Re: Project Update and Response to WDNR Comments/Questions Regarding the Remedial Progress Report and Groundwater Treatment Plan One Hour Martinizing 285 E. Hampton Ave Milwaukee, Wisconsin 53217 BRRTS#: 02-41-543260 FID#: 241176650

EnviroForensics, LLC (EnviroForensics) has reviewed your comments and questions presented in your October 1, 2018 letter regarding our submittal of the Remedial Progress Report and Groundwater Treatment Plan for the One Hour Martinizing site located at 285 E. Hampton Avenue in Milwaukee, Wisconsin.

Figure	9
Project	6194

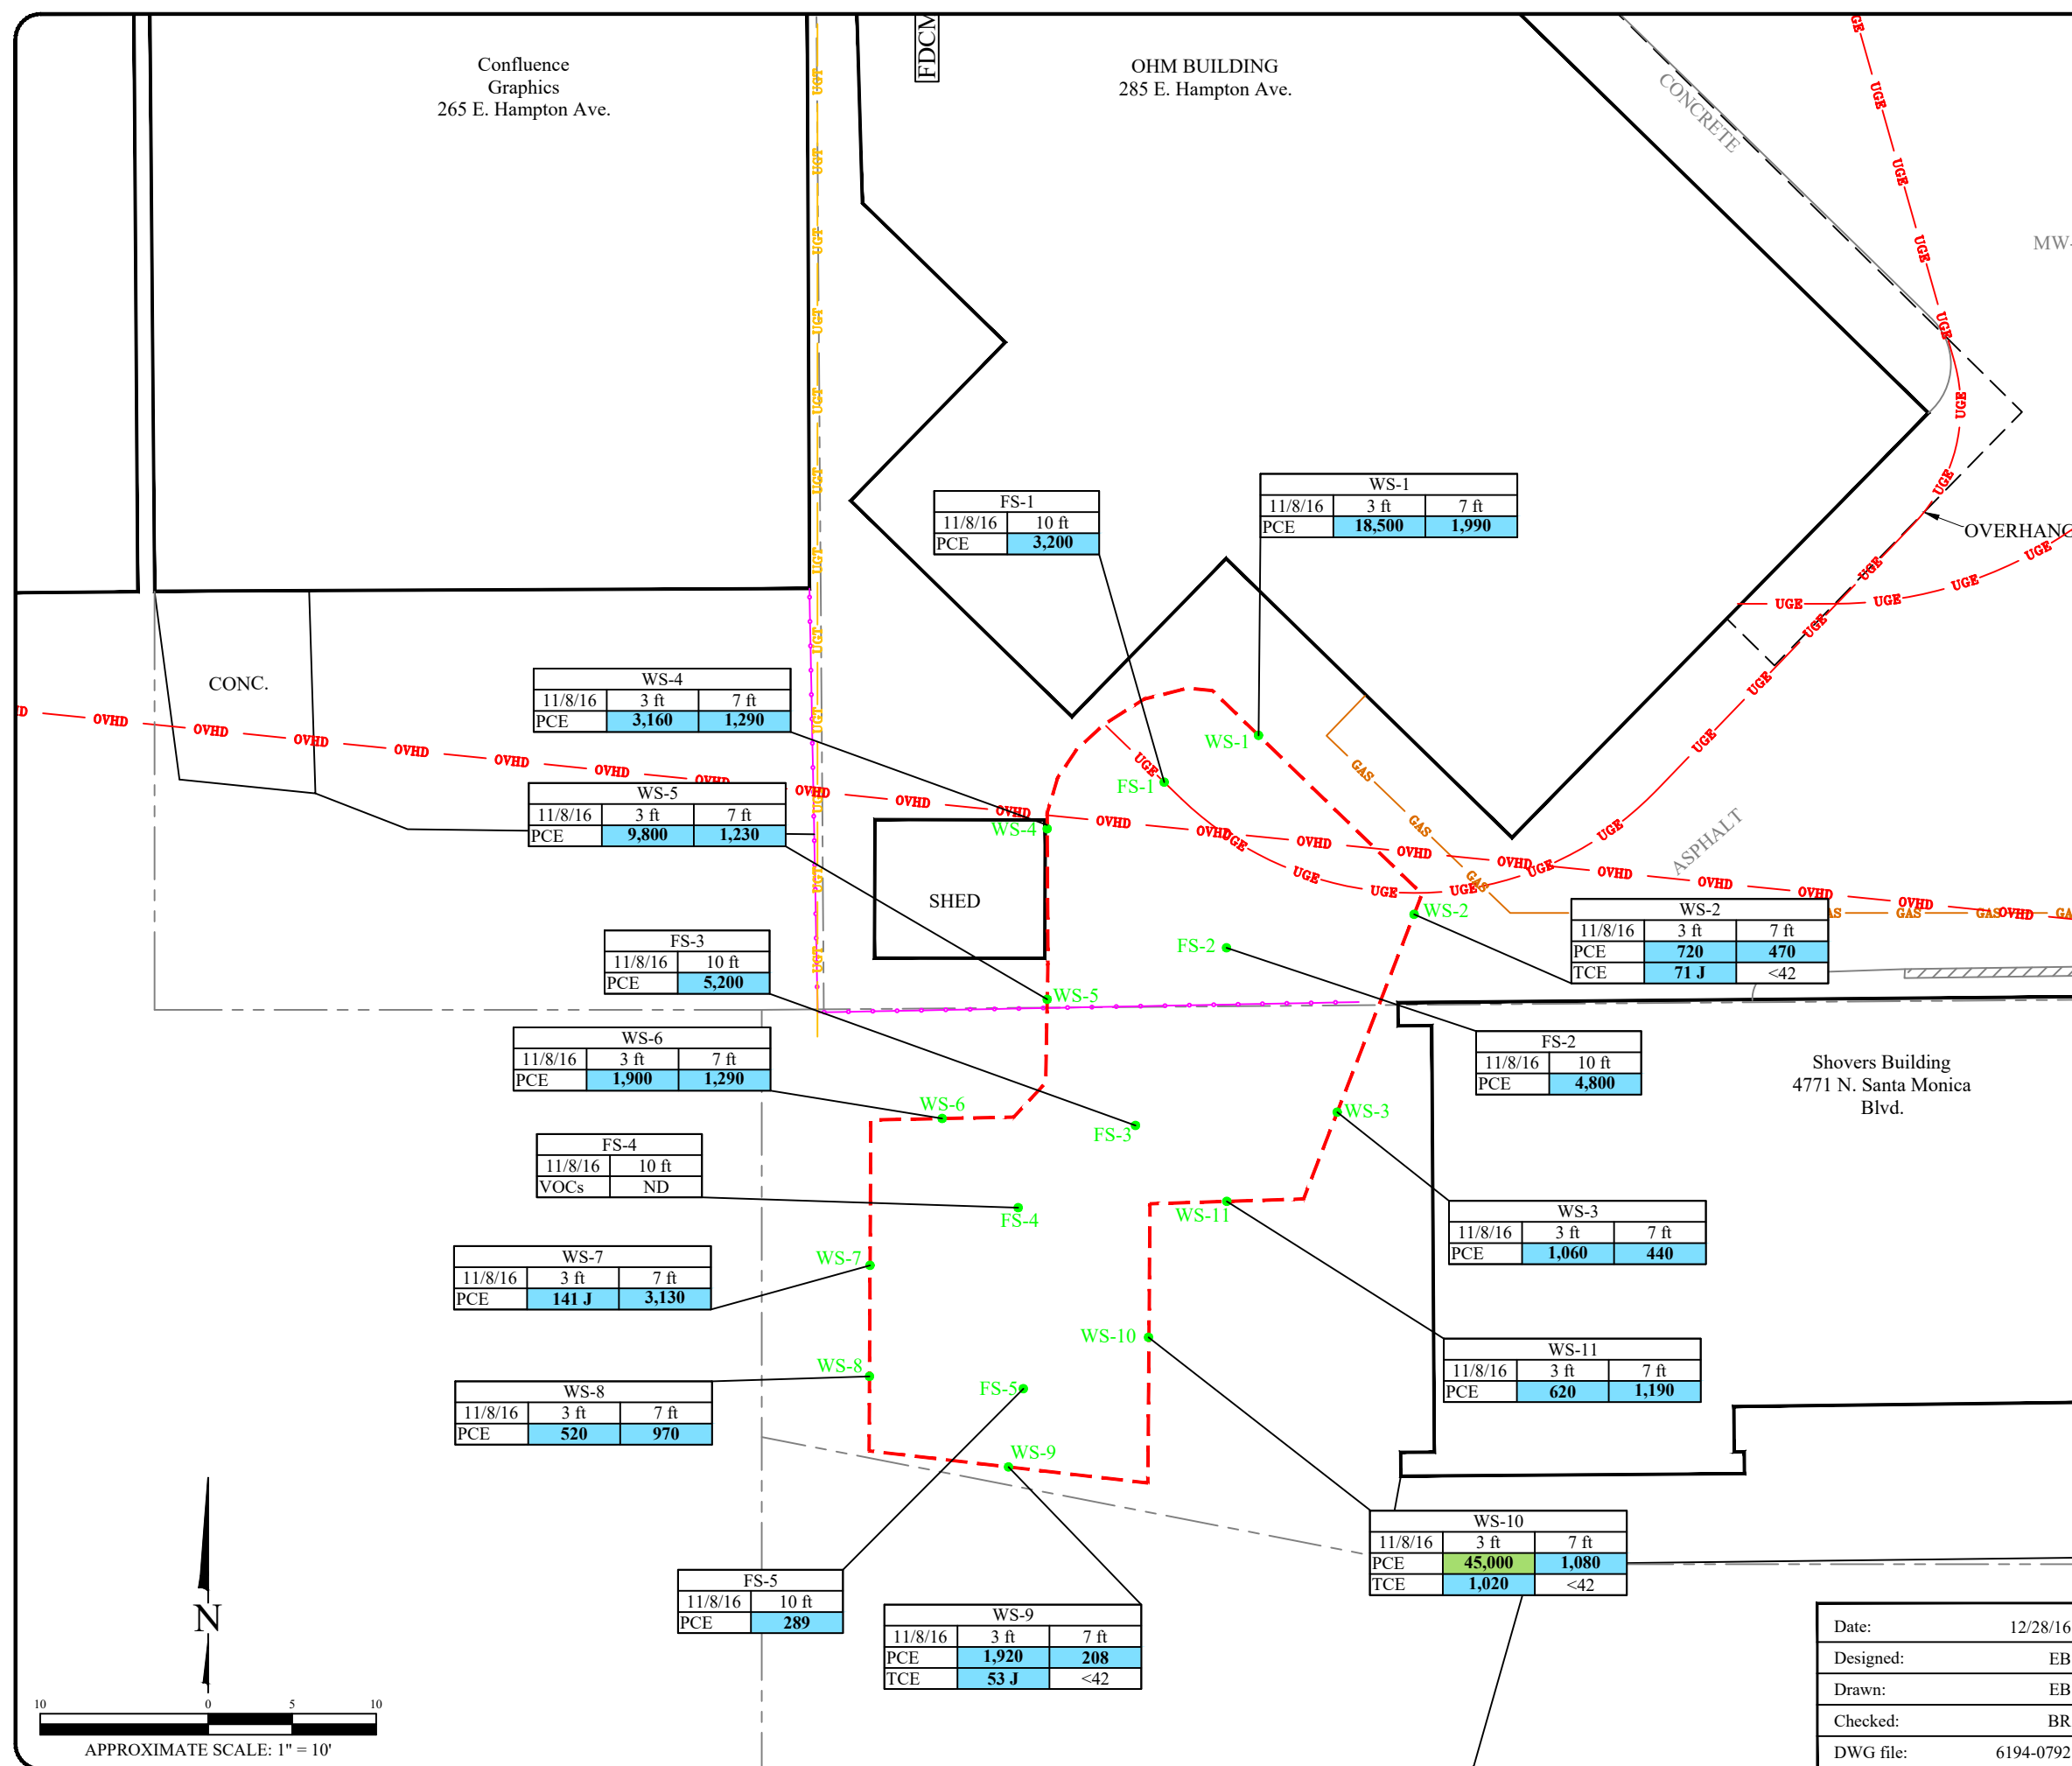
Question #2: High PCE concentrations were identified in the excavation sidewall confirmation samples collected onsite and offsite on the Shovers property and residual solvent contamination extends onto the Clark Station property (see Figure 9). Prepare a figure delineating residual contamination in the source excavation and include sample depth and contaminant concentrations. Clearly identify where the extent is inferred and determine where additional sampling is needed to delineate the extent and degree of contamination offsite at concentrations above residual contaminant levels.

Answer: Attached **Figure 8** provides the depths and location of soil samples collected prior to remedial excavating and the results of laboratory analysis for CVOC's. Attached **Figure 9** provides the depths and location of soil samples collected from the sidewalls and floor of the remedial excavation and the results of laboratory analysis for CVOC's. It is evident from the data presented on these figures that CVOC impacts at concentrations exceeding the soil to groundwater residual contaminant level (RCL) exist upon the Shovers Realty and Clark Station properties. Recent soil sampling presented on **Figure 1** indicates that soil impacts above the soil to groundwater RCL also exist on the south portion of the Confluence Graphics property. Upon resolving access issues, we will complete soil sampling at the locations indicated on **Figure 1** to better define the areas needed for cap maintenance or where special soil handling and disposal methods may be needed if excavating is planned by property owners in the future. The extent of these soil impacts will be presented on one (1) figure combining all past detections from the various existing figures.

Figure	14
Project	6194

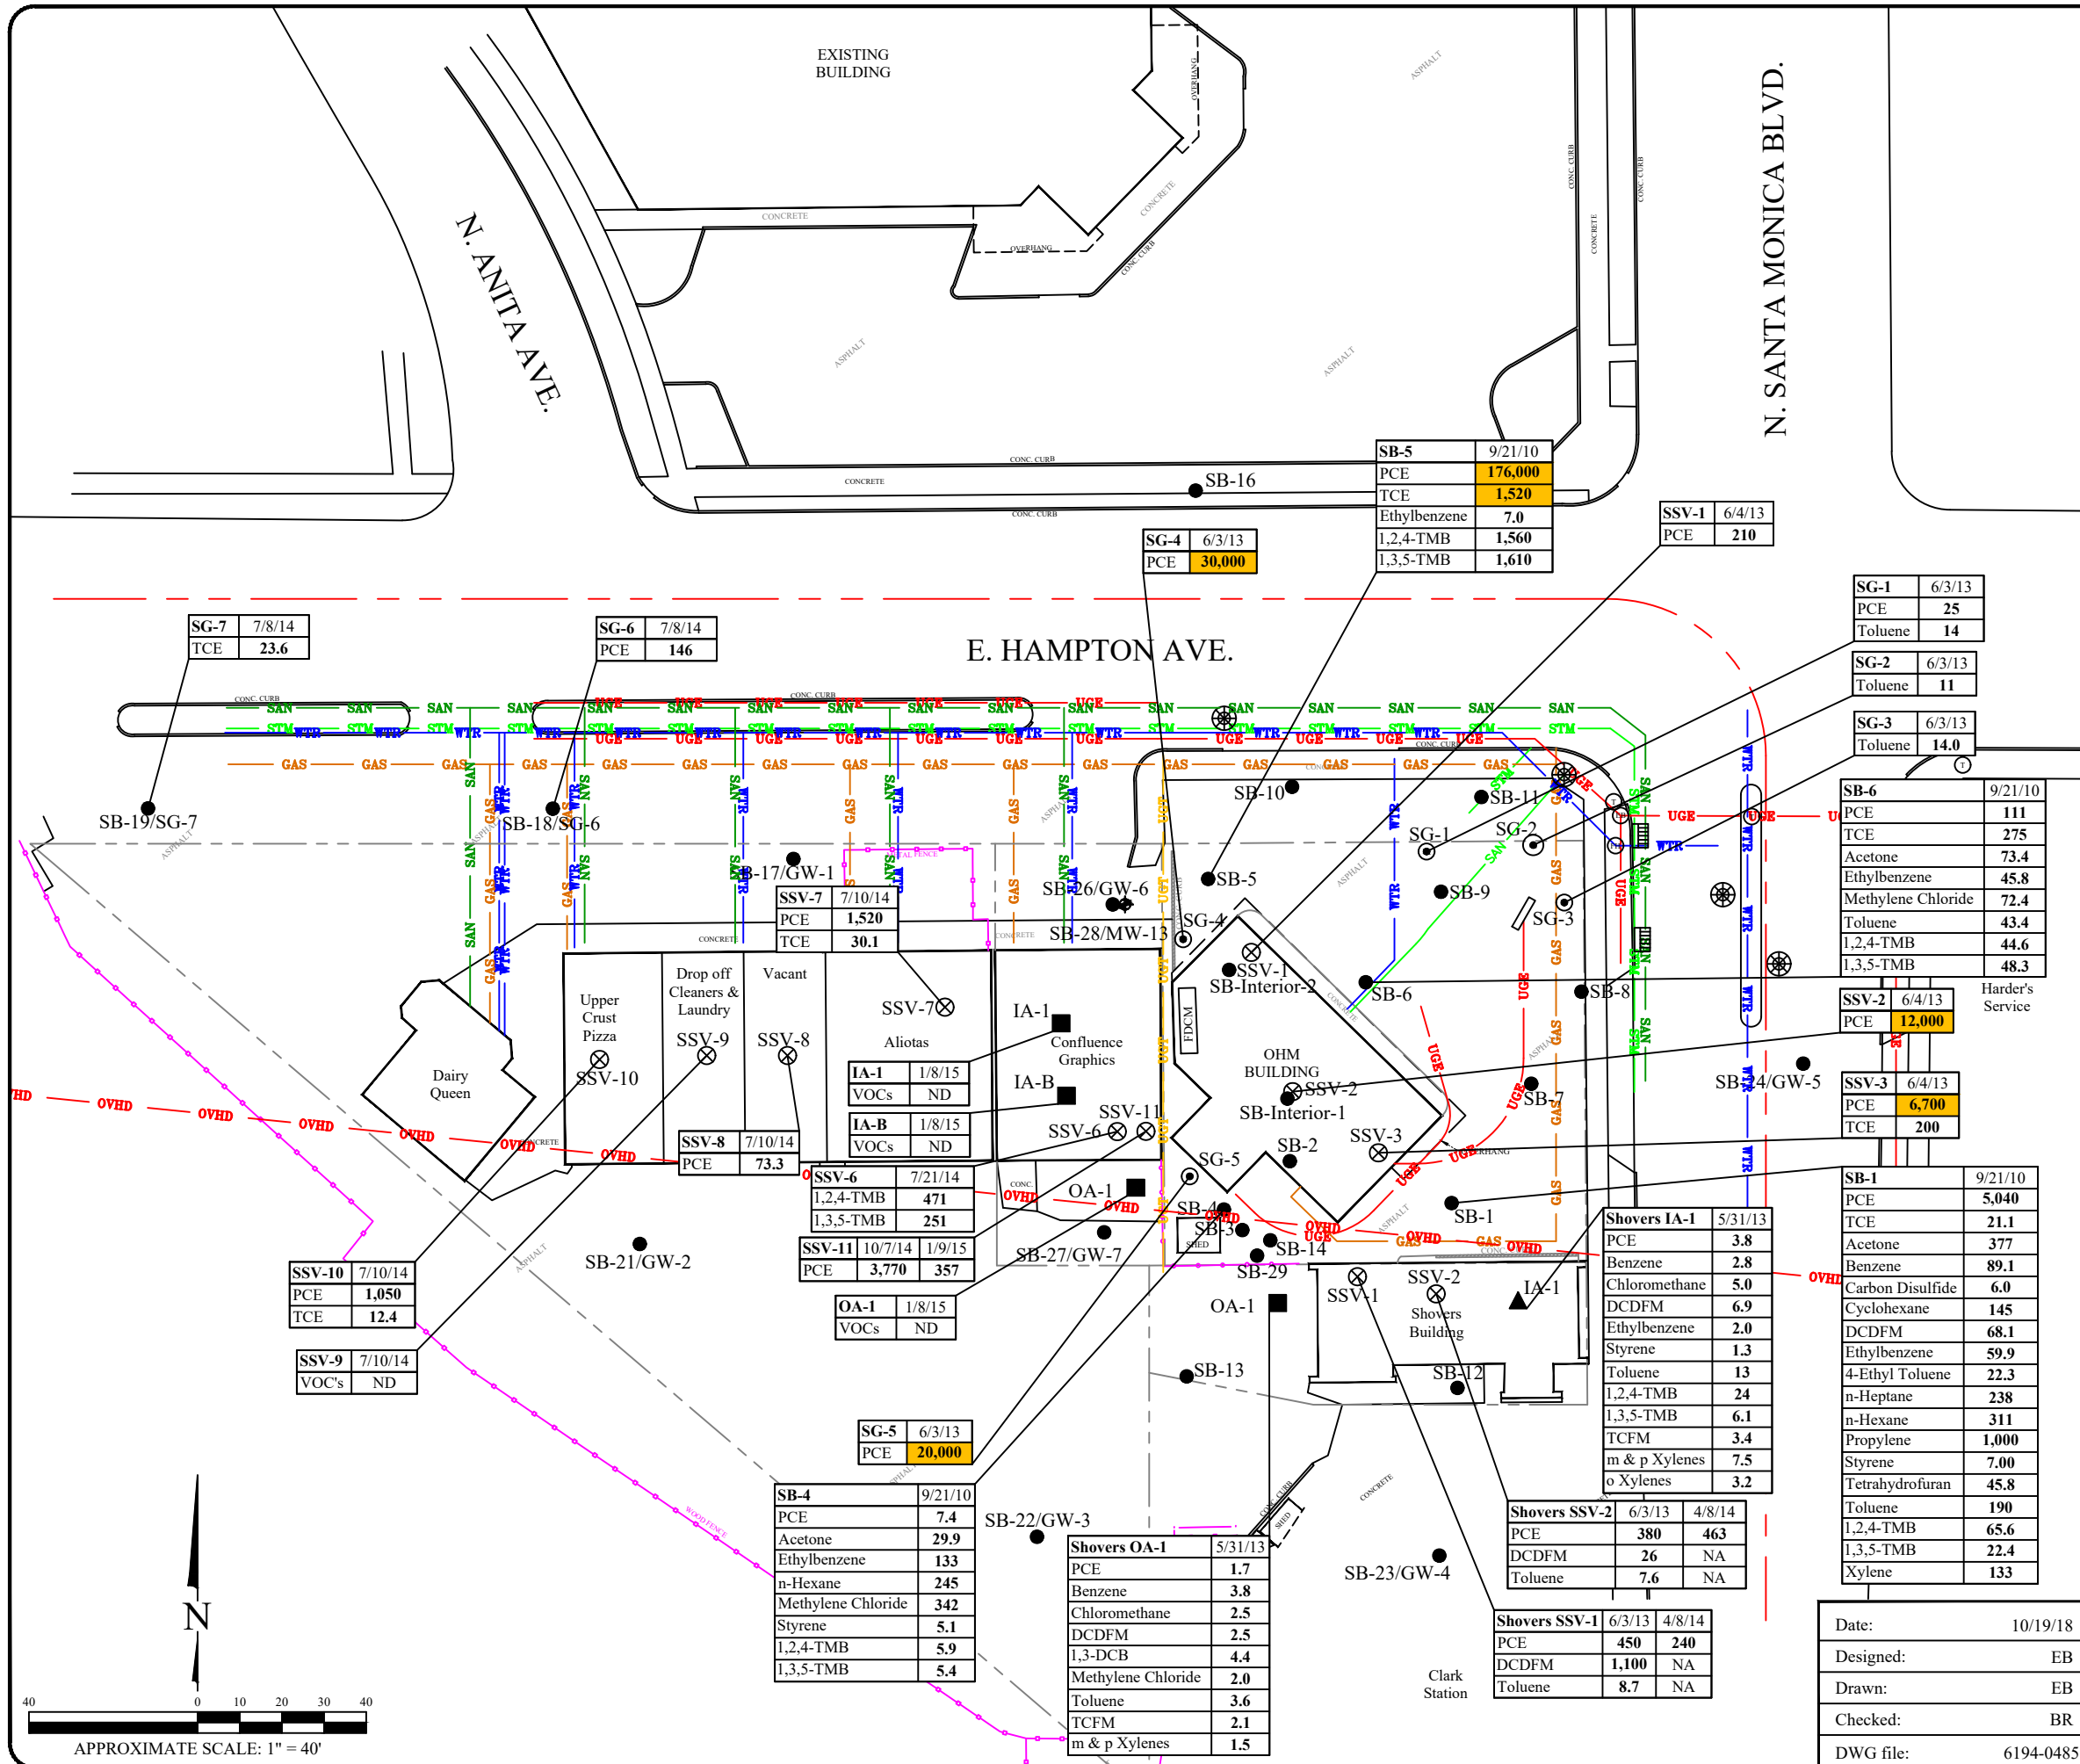
Question #1: An underground fiber optic line runs north-south between the One Hour Martinizing (OHM) and Confluence Graphics buildings. The fiber optic line may intersect the gas and water lines that are located above the groundwater table (see attached Figure 14 and 4) and has the potential to allow vapor migration westward along the gas and water lines. Soil gas locations SG-5 (PCE = 20,000 ug/m³) and SG-4 (PCE = 30,000 ug/m³) are nearest the fiber optic line. Soil data at boring SB-5 (PCE = 176,000 ug/m³ and TCE = 1,520 ug/m³), SG-4, and SG-5 are in areas that aren't near the source area. Determine the source of elevated soil gas and soil contamination in these areas.

Question #7: Vapor risk screening levels (VRSLs) have changed since sub-slab and soil gas samples were collected. Revise vapor tables and compare soil gas and sub-slab sample results to current VRSLs. New vapor results figures should be prepared using current standards.

Answer: The concentration of PCE in soil gas at SB-5 was 176,000 micrograms per cubic meter ($\mu\text{g}/\text{m}^3$). The concentration of PCE in soil at SB-5 was only 449 micrograms per kilogram ($\mu\text{g}/\text{kg}$) at a depth of 4-6 feet.

The locations of the old dry cleaning machines are presented on revised **Figure 14** (attached). During recent installation of a sub-slab depressurization system (SSDS) at the Site building in October, 2018, we noticed a significant open joint between the floor slab and outside wall at this location (it was sealed during installation of the SSDS). It is likely that if PCE (whether in pure or dilute form) was spilled on the floor near this open joint it would have leached into soil around the building footing and could have entered the nearby trench of the fiber optic cable. The cable trench may have acted as a conduit to transport PCE and associated PCE vapors further to the north as you have suggested.

As can be seen on **Figure 14**, concentrations of chlorinated volatile organic compounds (CVOCs) were not detected in soil gas at concentrations posing a vapor risk along the gas main at SG-6 and SG-7. These samples were collected at the depth of, and within six (6) feet laterally of the gas main. Also, sub-slab vapor sampling was performed at Confluence Graphics and all units within the multi-unit commercial building adjacent to the west of Confluence Graphics (former Aliota building). CVOC vapors were not detected at concentrations exceeding past or current vapor risk screening levels (VRSLs) in any of these buildings/commercial units. Therefore, the data suggests that widespread vapor migration to the west has not occurred along utility conduits.

Answer: The establishment of a new attenuation factor for soil vapor has resulted in risk levels being raised, not lowered. Therefore, the risk of vapor intrusion to buildings has decreased, not increased. We have revised Figure 14 taken from the Site Investigation Report to reflect the revised VRSLs. We will present figures and tables with the new VRSLs as new documents are created. The Dairy Queen building does not appear to be at risk of vapor intrusion based on sub-slab vapor samples collected within all four (4) units of the Aliota-owned commercial strip building, and that the Dairy Queen is greater than 100 feet from the source area.
